Subject: Report of Potential Defect

ITT Barton is a supplier of basic components to the nuclear power industry. The specific components being reported are our Model 763 and 763A Static Pressure Transmitters.

MODEL 763/763A GAGE PRESSURE TRANSMITTER

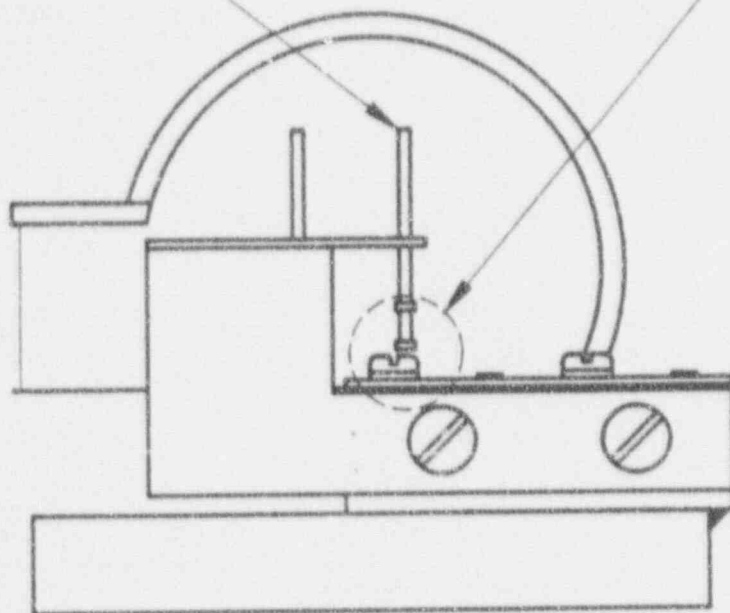
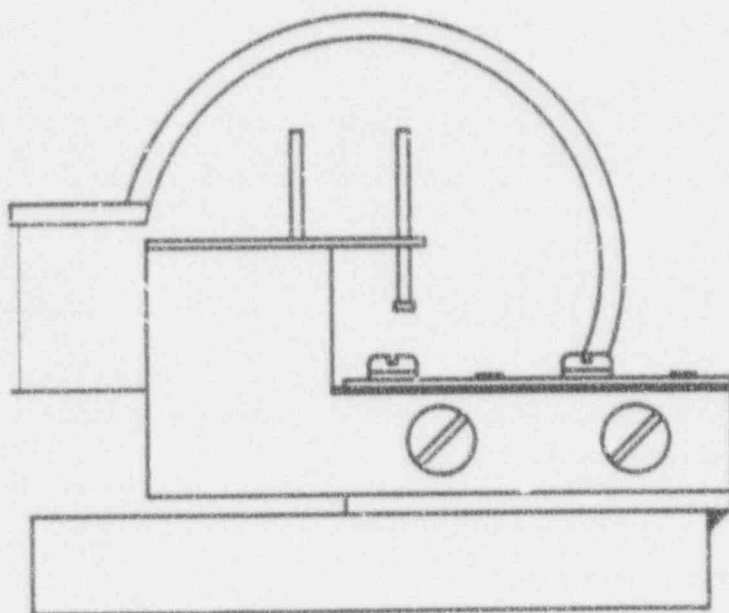
The reported failure was the result of a short circuit of a connector pin to an adjacent mounting screw (see attached sketch). The pin would normally be clipped off during manufacturing to avoid a short. However, documentation was not updated to reflect this requirement.

AREA OF
POTENTIAL
SHORT

IS: POTENTIAL INTERFERENCE OF UNCLIPPED CONNECTOR
PIN WITH SCREW HEAD

Engineering drawings and manufacturing work instructions are being changed to provide clear direction to clip the connector pin and to inspect the pin upon completion. Existing stock will be purged to assure implementation of these changes. Instructions will be provided to all users for correction of the deficiency in delivered instruments. All of these actions will be completed by December 20, 1991.

SHOULD BE: CLIPPED CONNECTOR PIN
